## 6-1– 12

### Proposed Change as Submitted

**6-5– 12**  
**604.4, Figure 604.4**

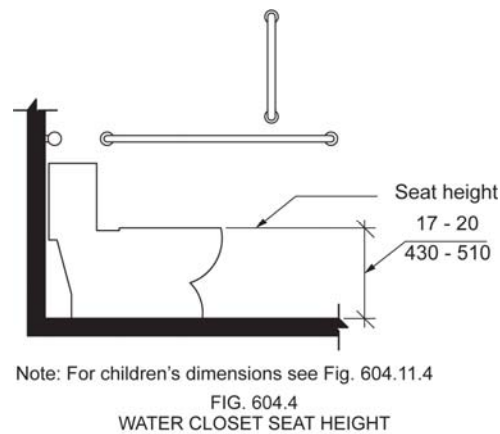
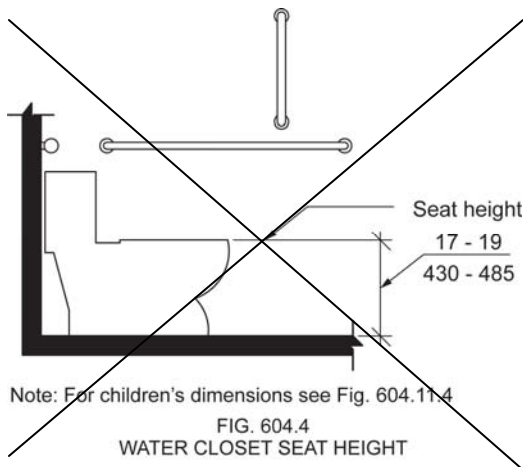
NOTE: This change necessitates a change to Fig. 604.4 to ensure consistency. Thus, the proposed revised figure has been attached, along with the existing figure for comparison purposes.

### 604.5.1, Figure 604.5.1

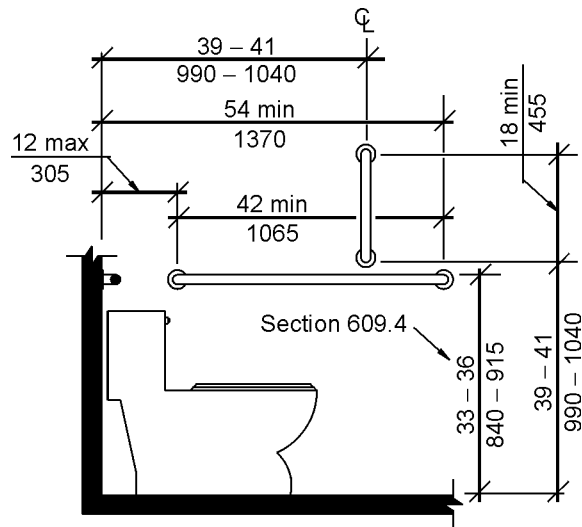
Change dimension call out dimension showing the location of the vertical grab bar in relationship to the rear wall as follows: ~~39 – 41 (990 – 1040)~~ to 39-46 (990 1170)

**Committee Reason:** The vertical grab bar is located in relationship to the water closet. Allowing it to be located further forward may reduce its functionality. The proposed change is not based on usability. Changes to the current dimensions should be based on information or studies that substantiate the effect on usability.

### 604.7, Figure 604.7

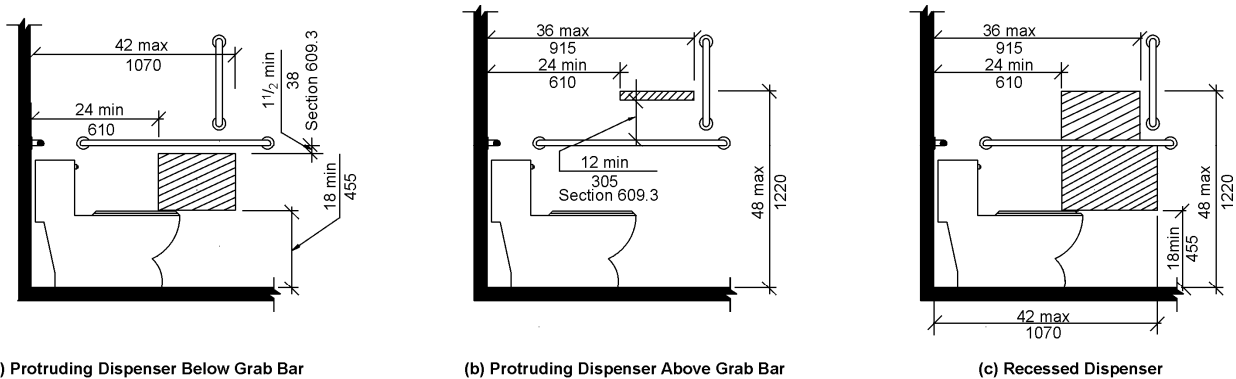
Change the vertical dimension on figures (a) and (c) indicating the vertical placement of dispensers above the floor from : ~~18 min (455)~~ to 15 min (380).

1. Inconsistent with ICC A117.1- 2009  
Section 3098.2 Forward Reach, 308.2.1 Unobstructed (Page 11), " low forward reach shall be 15 inches (380 mm) minimum"  
Figure 308.2.1 Unobstructed Forward Reach (Page 11), dimension call out "15 min (380 mm)"  
Section 308.3 Side Reach, 308.3.1 Unobstructed (Page 13, " low side reach shall be 15 min (380 mm)"

2. Inconsistent with 2010 ADA Standards  
Section 604.7 Dispensers (page 201), "the outlet of the dispenser shall be 15 inches (380 mm) minimum"  
Figure 604.7 Dispenser Outlet Location (page 202), dimension call out "15 min (380 mm)"

**Table 604.9.3.1, Figure 604.9.3.1**

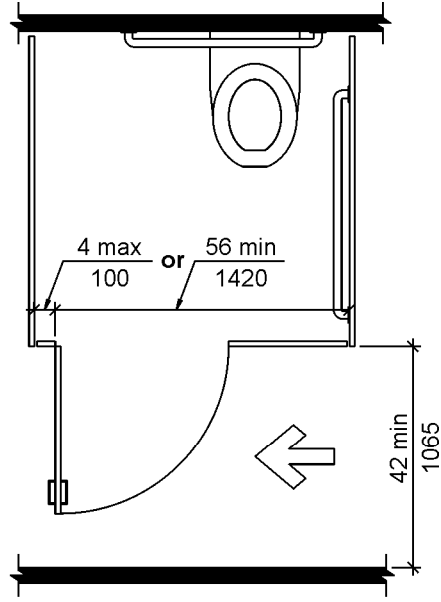
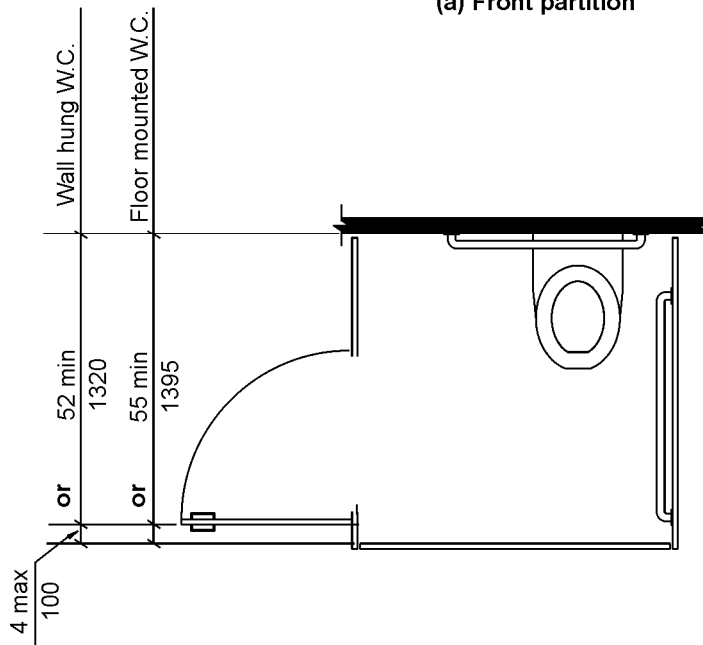
Change the called dimension for door opening location to read: 4 inches (100 mm) minimum to 6 inches (150mm) maximum.

**Committee Reason:** The change would make the table more difficult to understand and therefore use. Changing from 4 inches maximum to a 4 inch minimum/6 inch maximum range would eliminate currently acceptable installations which are less than 4 inches.

### **Figures 604.9.3.1 (a), (b), (c), Figure 604.9.5 (c)**

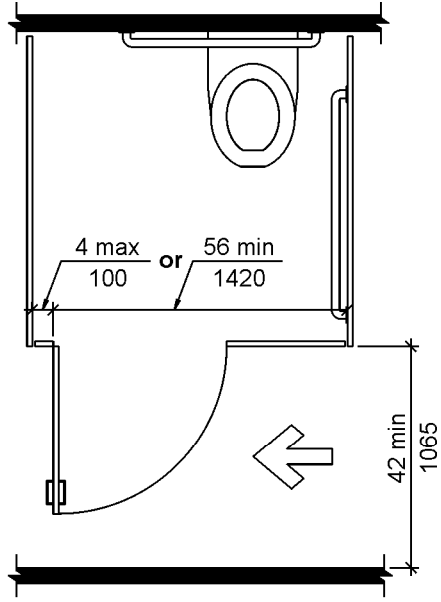
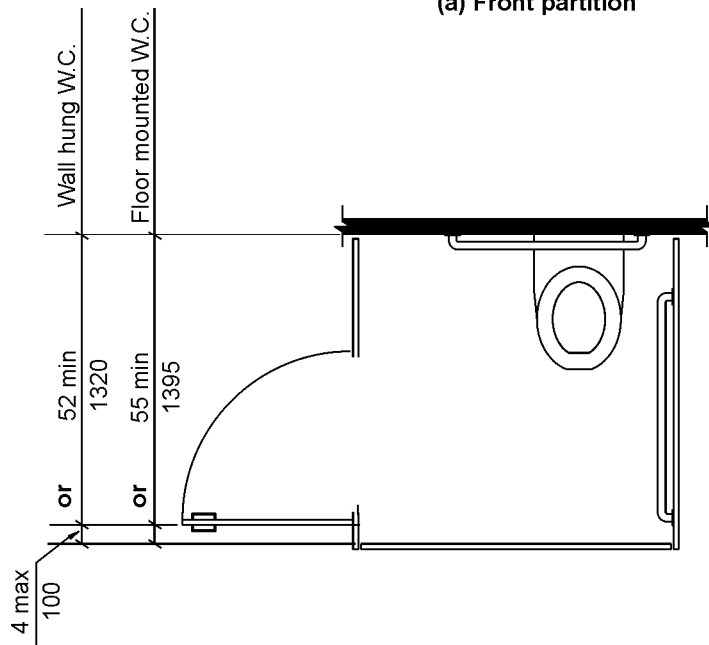
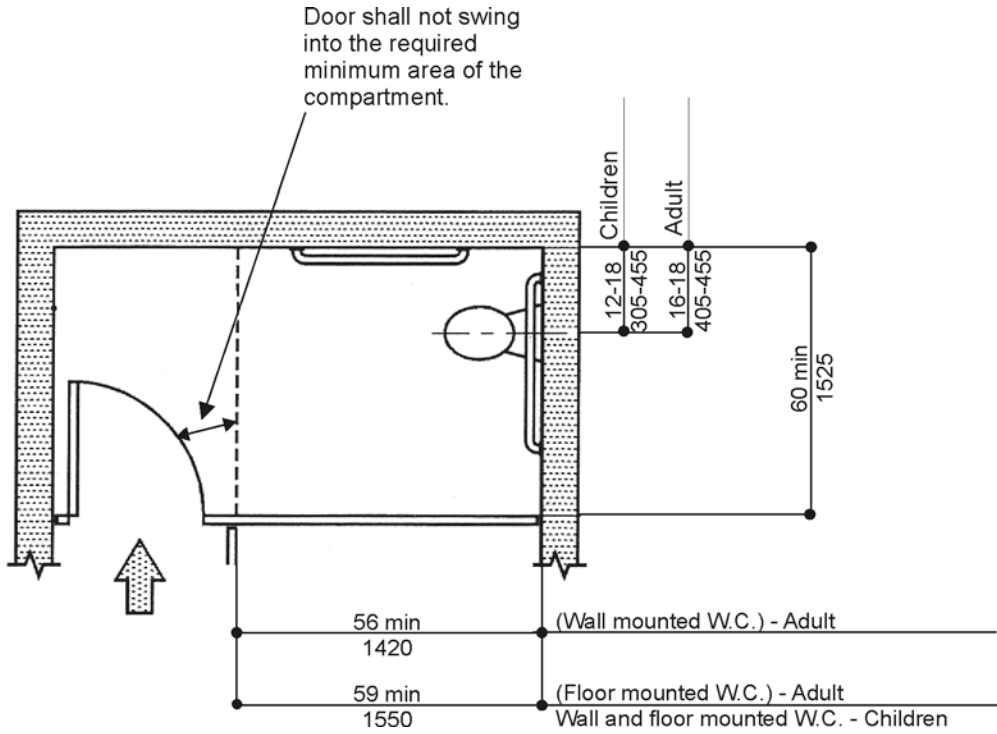
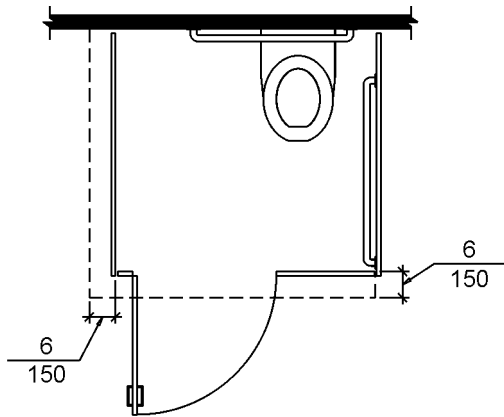
Revise each figure to indicate the placement of the vertical grab bar required for each.

**Reason:** Figures 604.9.3.1(a), (b), (c) and 604.9.5 (c) do not reflect a vertical grab bar. Though these figures clearly address wheelchair accessible compartment door openings, they should be consistent with other illustrations which address other elements within the compartment yet reflect the vertical grab bar. To maintain consistency among Figures, the vertical grab bar should be reflected in these illustrations. The vertical grab bars are reflected in other figures – for example: Figures 604.9.2 (a), (b) address wall hung and floor mounted water closets yet they reflect a vertical grab bar in the illustrations. Example: Figures 604.9.2 (a), (b) specifically address wall hung and floor mounted water closets yet they reflect a vertical grab bar in the illustrations.

### **604.9.5, Figure 604.9.5, 609.5.1, 609.5.2**

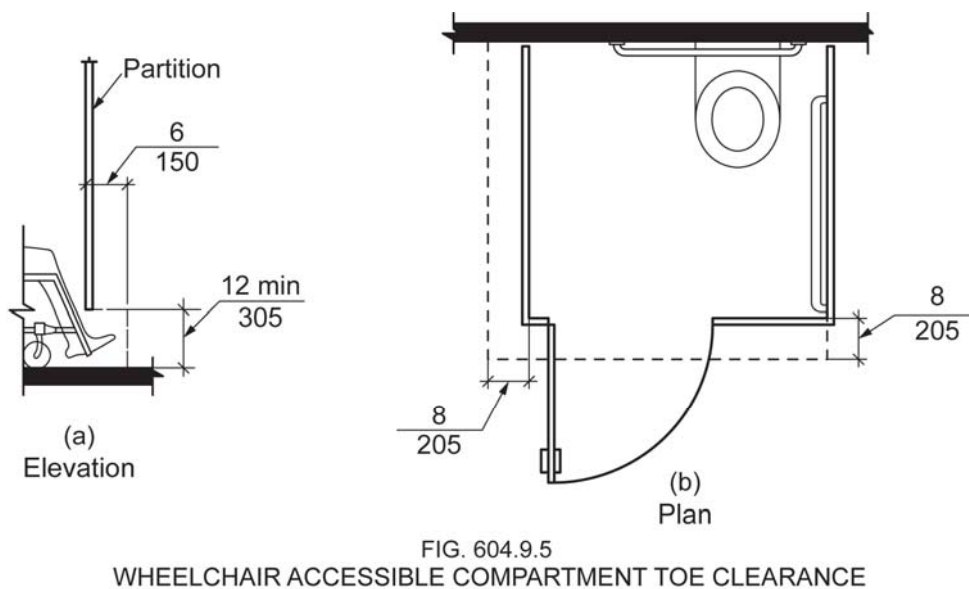
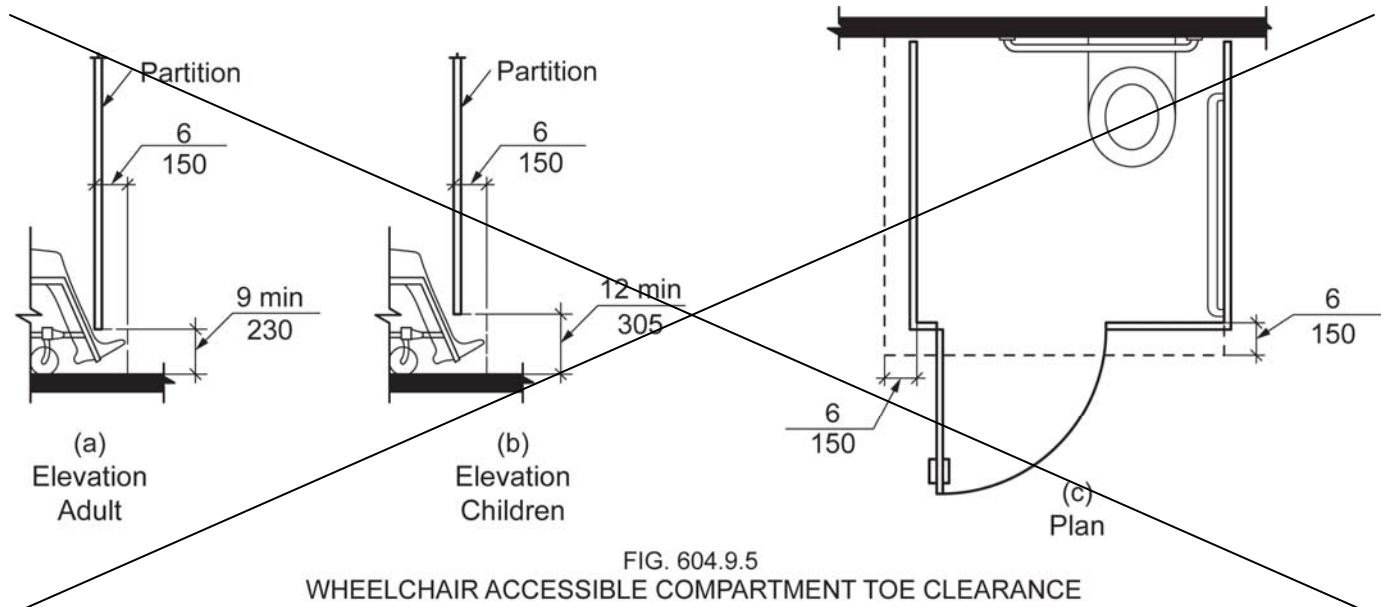
These figures assume the wheelchair occupant is as far forward to the partition as possible but it does not account for the total occupied length of the device. Based on the existing ANSI standard, we propose that the exceptions be changed accordingly to account for the additional 2 inches of space added for toe clearance. This means that if an adjacent compartment does not have the requisite 8 inches, the accessible compartment must have 2 more inches than previously required in order to be exempted. Further, Steinfeld, et al., 2010 (pg. 95, fig. 4-5) notes that in order to allow 95% of power and manual wheelchair users to perform a 180-degree turn, a 67-inch width is necessary, which is consistent with the proposed change to the exemptions.

NOTE: This change necessitates a change to Fig. 604.9.5 to ensure consistency. Thus, the proposed revised figure has been attached, along with the existing figure for comparison purposes.

**Fig. 604.10**  
**Ambulatory Accessible Compartment**

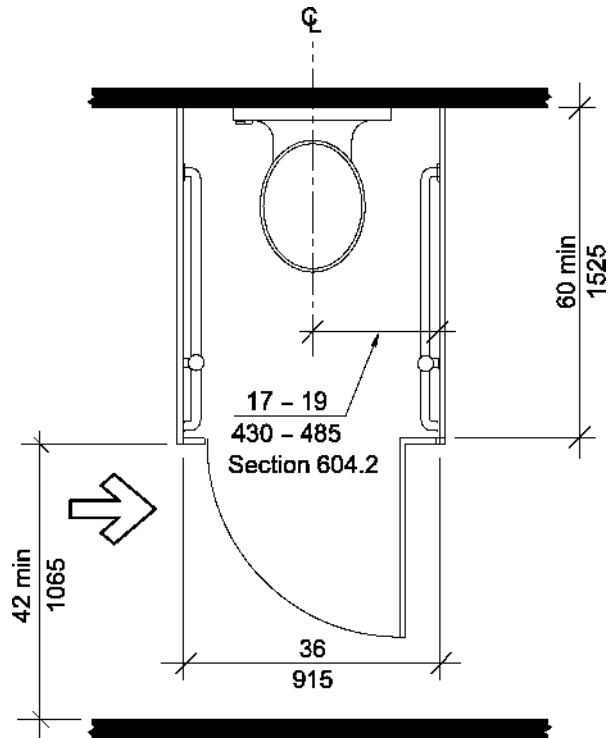
Change the called out dimension for the width of the compartment from ~~36 (945)~~ to 40 inches (1015)

1. A 40" Ambulatory Accessible compartment would allow use of a 3" wide stile on each side of the door opening. The 3" wide stile would provide room for attachment of door hinges and latch keepers. The 3" wide stiles would provide more structural support and rigidity for the side panels and the door hinging and closing than a 1" wide stile or wall post. The 3" wide stile conforms to toilet partition industry standard practice. The 1" wide stile or wall post is not standard.

**6-30– 12**  
**Figure 604.11.7**

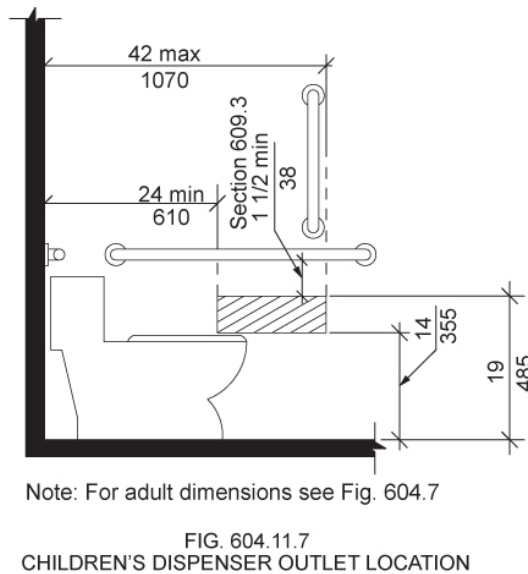
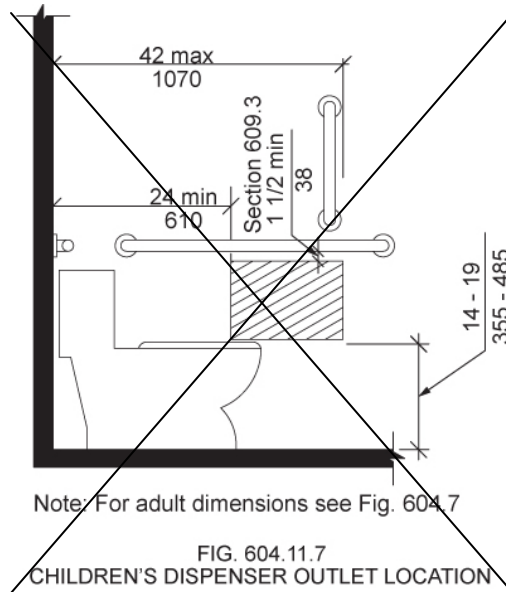
**Reason:** Section 604.11.7 requires, "The outlet of the dispenser shall be 14 inches (355 mm) minimum and 19 inches (485 mm) maximum above the floor." However, the existing figure does not accurately depict this condition. The figure depicts the bottom location of the dispenser as being within a range of 14-19 inches, but gives no dimension for the top of the dispenser. The figure should be corrected to more accurately reflect the text. It should label 14 inches to the bottom of the shaded area, and 19 inches to the top of the shaded area. The existing drawing was included above for reference purposes.

**Fig. 604.12.3**  
**Elder Size of Clearance for Water Closet**

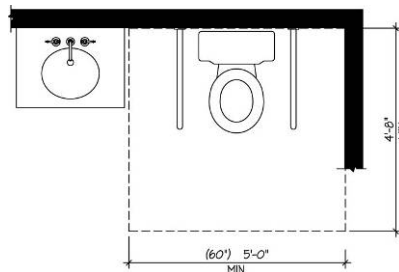
**604.12.3.1 Size** A clearance around a water closet 60 inches (1525 mm) minimum, measured perpendicular from the sidewall, and 56 inches (1420 mm) minimum, measured perpendicular from the rear wall, shall be provided.

**Reason:** Increased side wall clearance. Space is needed on both sides of the toilet to accommodate the range of transfer techniques including the front approach normally used in independent sit to stand transfers; caregivers to stand on either or both sides, for one- or two-person assisted transfers as necessary; and for use of a mechanical lifting device.

**Committee Reason:** The intent of the proposal is to establish standards for toilet facilities where elderly persons can be easily assisted in these functions. The Committee felt that the basic premise of this and the related proposals is contrary to the principal premise of the A117.1 Standard which is to provide design standards by which people with disabilities can do things for themselves without assistance. The Committee suggested that at best these provisions could be an appendix to this standard or perhaps a distinct standard developed under the umbrella of this Committee. The Committee identified provisions such as grab bars not installed to be in a permanent position. This presents an issue for people who need to push up on a grab bar. Location of grab bars eliminates the use of elbows during transfer. If transfer is an intended option, why is clear floor space not provided. Finally, the Committee was concerned that it had no control over the scoping of these designs and worried that such could be provided instead of the toilet facilities current contained in the standard. If they seek scoping via the International Building Code, the use of terminology similar to family/assisted use would conflict the current use of such term in the IBC. It describes a fully accessible facility.

**Fig. 604.12.7**  
**Dispenser Location**

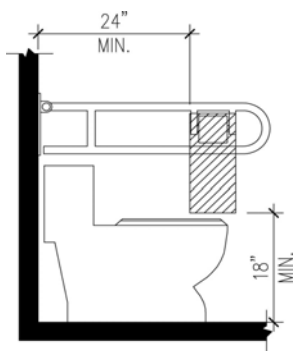
**604.12.7 Dispensers.** Toilet paper dispensers shall comply with Section 309.4 and shall be located on the fold-up grab bar 3 inches (76 mm) maximum behind the front of the water closet measured to the center line of the dispenser. The outlet of the dispenser shall be 21 inches (533 mm) minimum above the floor. There shall be a clearance of 1 inch (38 mm) minimum below the grab bar. Dispensers shall not be of a type that control delivery or do not allow continuous paper flow.

**6-34– 12**  
**606.3, Figure 606.3**

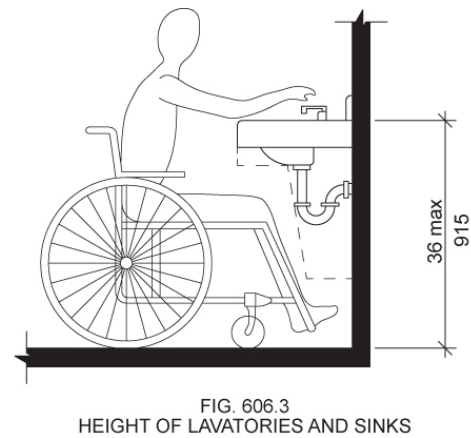
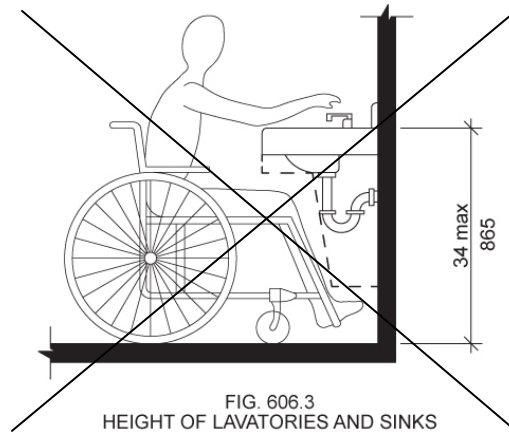
A proposed change to Section 306 would raise the knee clearance height minimum to 29 inches, up from 27 inches, a difference of 2 inches. Changing the maximum rim height by the same 2 inches would allow many existing lavatory products to still comply with the standard by only being mounted 2 inches higher. Steinfeld, et al., 2010 demonstrates that the limiting factor in reaching a target (faucet controls, for example) when using a forward approach is not the height of the obstruction; it is the depth that influences control reachability for people using wheeled mobility devices. This proposal will allow more wheelchair users to get a forward approach to the lavatory, as is often required for use of the lavatory.

NOTE: This change necessitates a change to Fig. 606.3 to ensure consistency. Thus, the proposed revised figure has been attached, along with the existing figure for comparison purposes.

FIG. 607.2(b)  
CLEARANCE FOR BATHTUBS

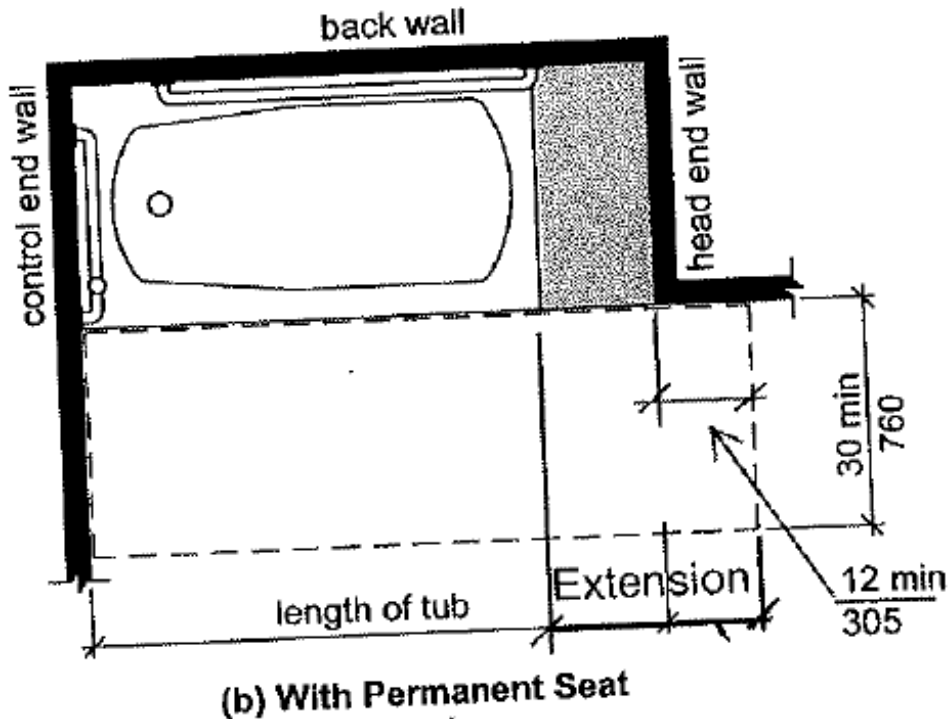
Section 607.4.1 sets the 'depth' of the seat. The current language skips the piece between the 'length of the tub' and the and of the extension. This is a technical issue that just gives you all the pieces. Please see graphic revision attached.

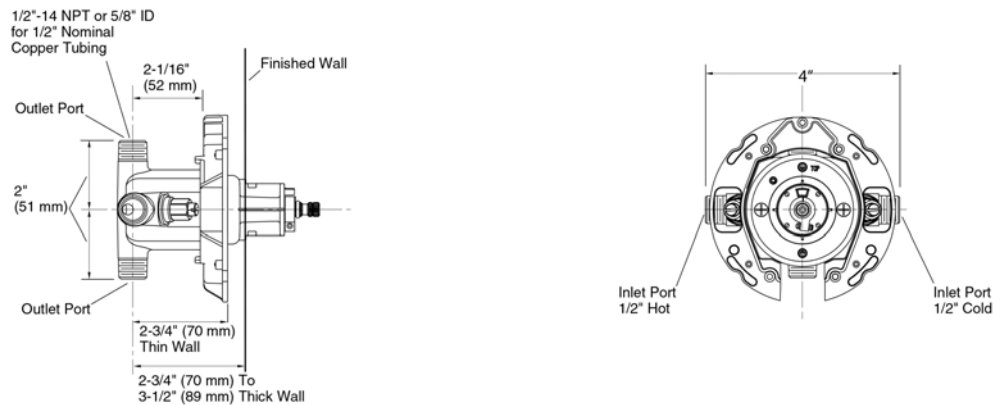
**607.2.1 Control Clearance.** Where the controls are located within 5" from the approach side of the bathtub the clearance shall extend 5 inches minimum beyond the control end wall. Where the controls measured from the approach side of the bathtub are located between 5 and 9 inches from the approach side of the tub the clearance shall extend 9 inches minimum beyond the control end wall.

**Reason:** Current Reach Ranges permit controls which realistically can only be used by 15% of persons with upper body mobility (those likely to bathe without assistance). 2012 Anthropometry of Wheeled Mobility Report, page 105, and elsewhere, indicates side reach is possible for far greater numbers of persons if feet extend beyond plane of the controls ("toe space").

**Committee Reason:** The Committee felt the result of the proposed text is unclear other than there is a concern that it will result in an increase in the size of bathrooms. The ergonomics of using this and the bathtub doesn't seem correct. There was concern this was based on the equipment of a single manufacturer.

**6-46– 12**  
**608.2.1.2, Figure 608.2.1**

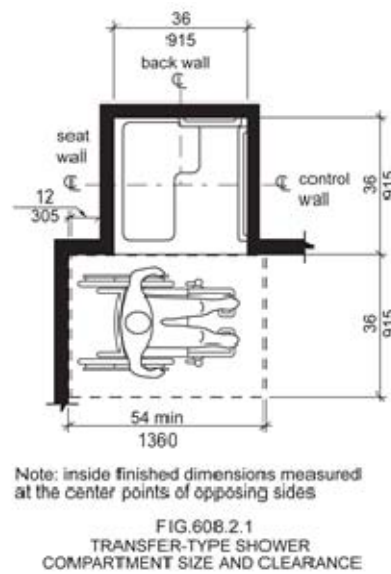
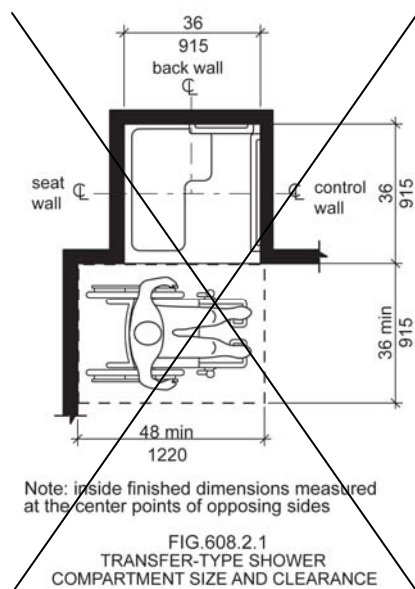
**Committee Reason:** With the increase in the clear floor space approved in Proposal 3-13-12, the clearance needs to be revised to accommodate the larger space. The result of the modification is to change the current 48 inches to 52 inches. The added 4 inches will occur 'at the toes' of the user. There was considerable debate whether the added space should be at the toes or at the back of the wheelchair or balanced. Information provided by the proponent is the location of the shoulders adjacent to the seat is the most important for this transfer.

**Note:** The Editorial task group should make sure that the figure clearly shows the measurement of the 12 inches be from the inside of the wall of the shower.
